CONSTRUCTION DOCUMENTS
FALCON MARKETPLACE
SE 1/4 OF THE SE 1/4 OF SECTION 1, T13S, R65W OF THE 6TH P.M.
11680 E. WOODMEN ROAD
FALCON, COLORADO

ISSUE	DATE
90% SUBMITTAL	5-6-19
REVISED	3-30-20
DESIGNED BY:	TDM
DRAWN BY:	KGv
CHECKED BY:	TDM
FILE NAME:	20988-CD-CVR

COVER SHEET

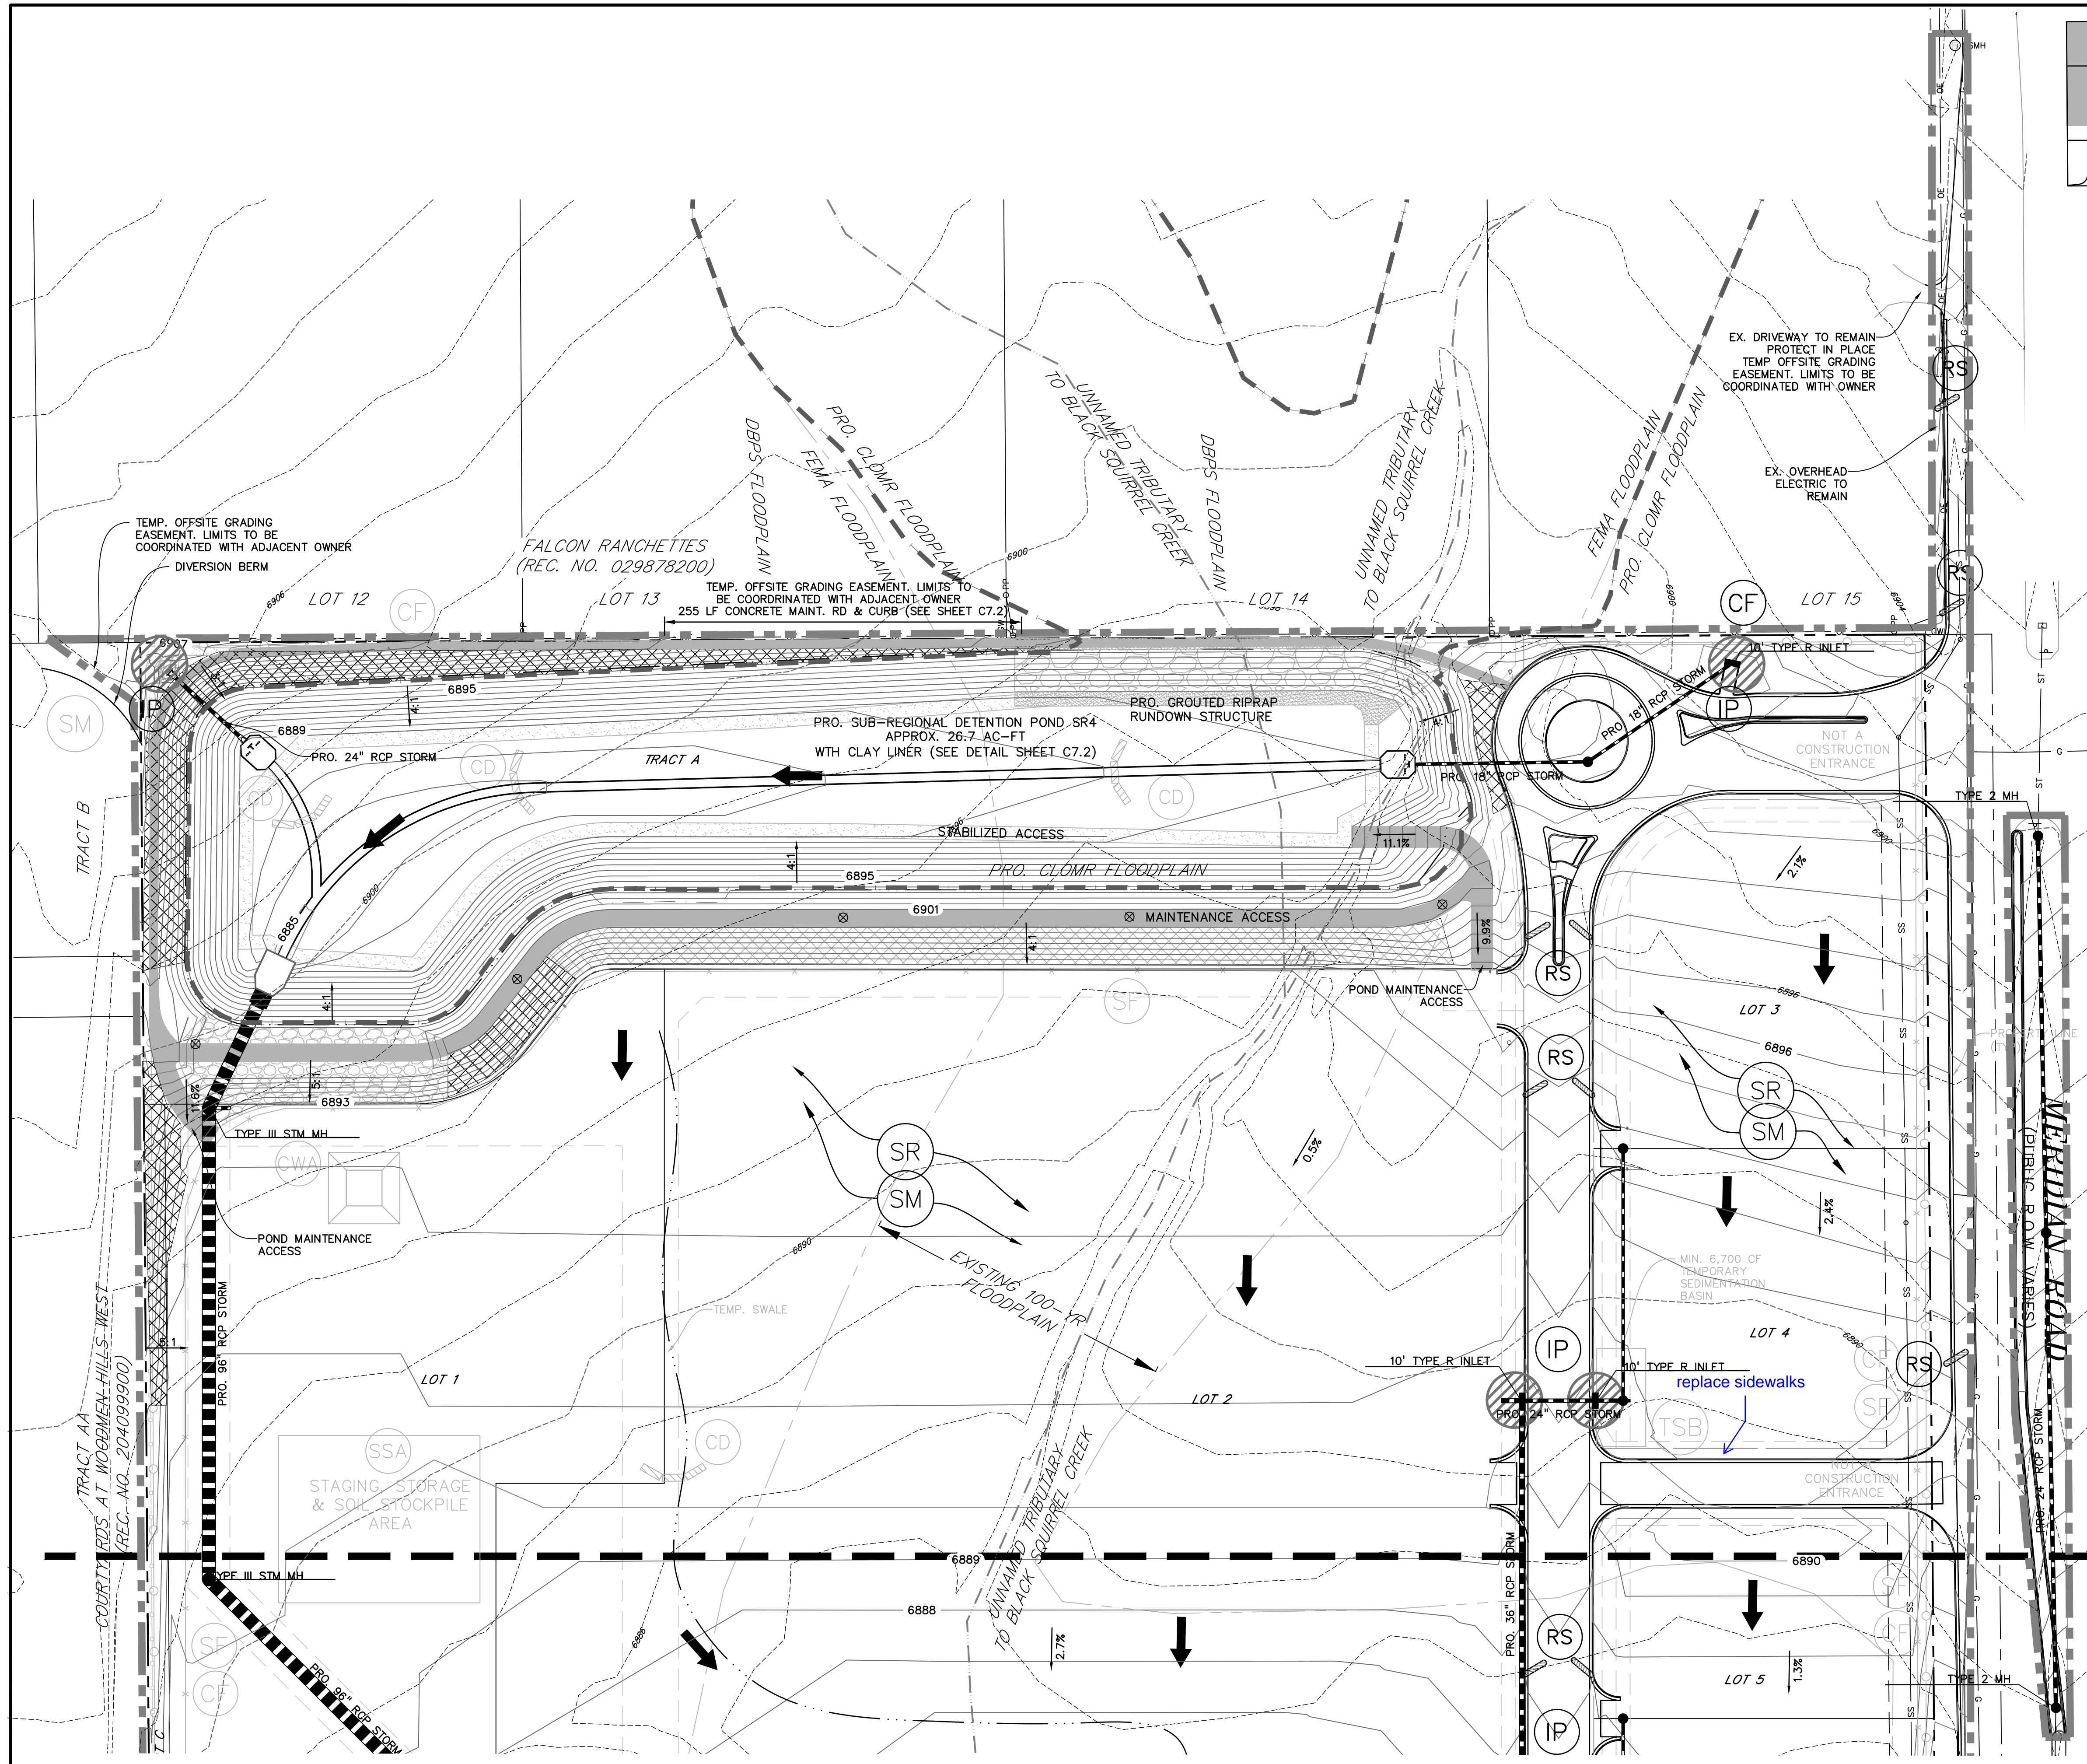
Please add sheet numbers too (1-47).

**SOUTH
ROUNDABOUT
PROFILES**

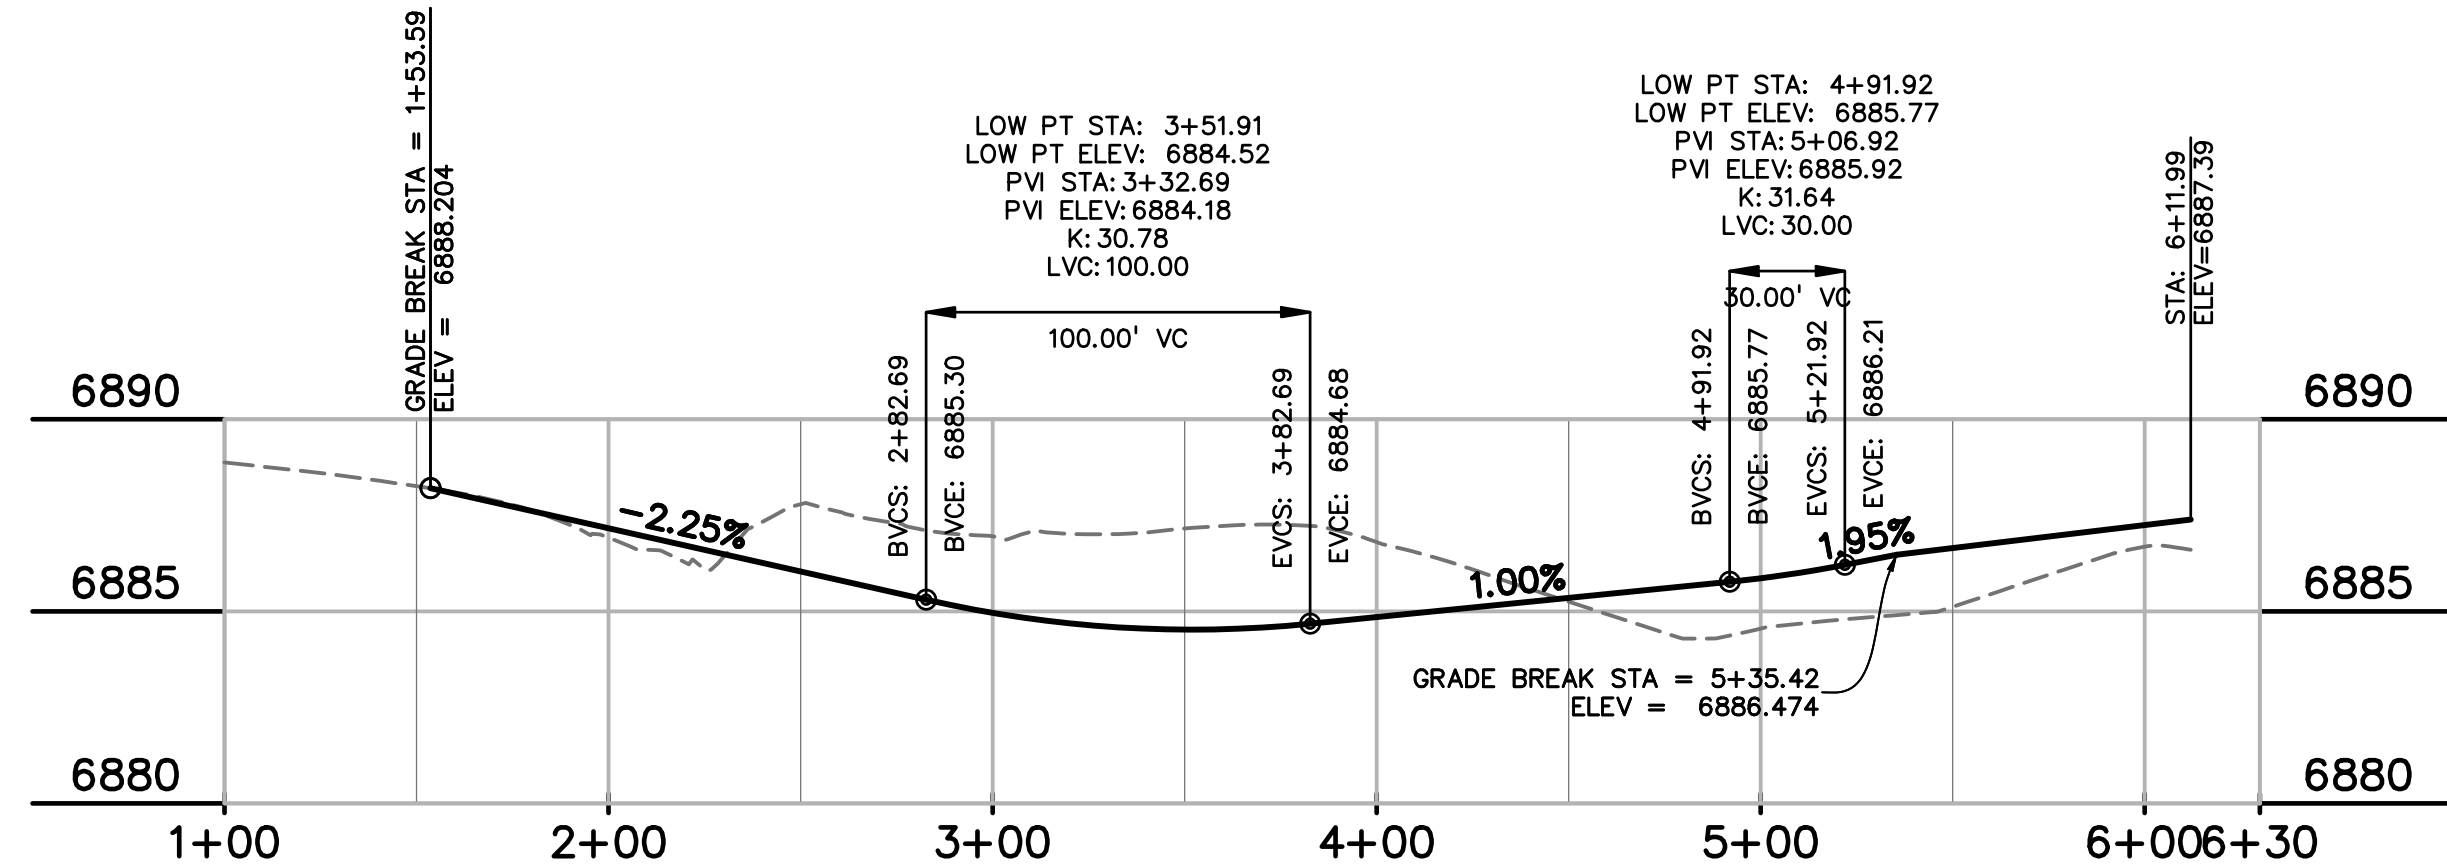
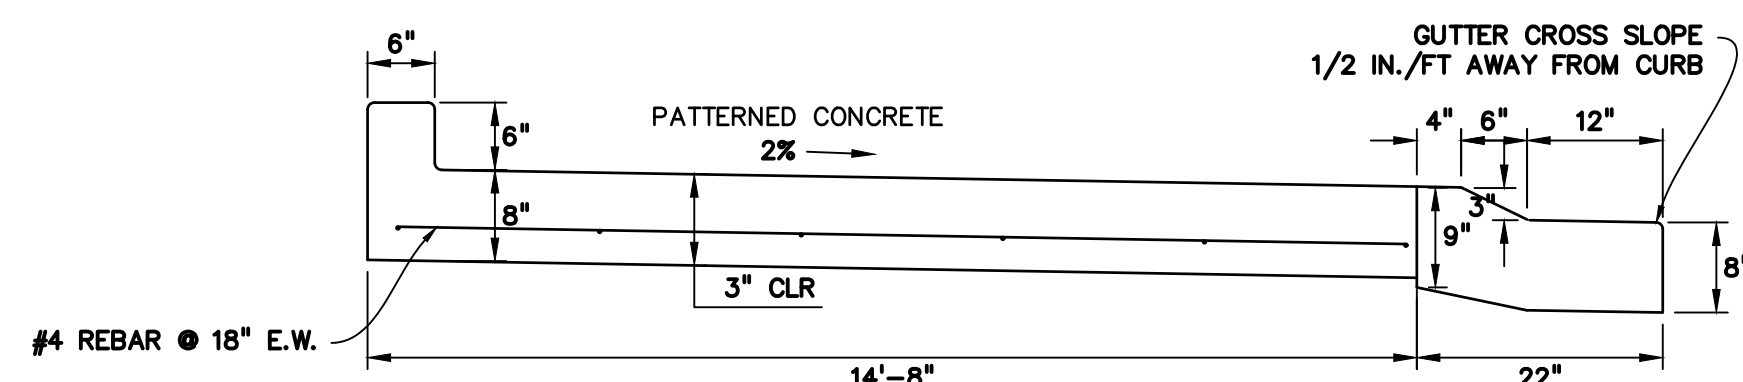
Are landscape profiles going to be added?
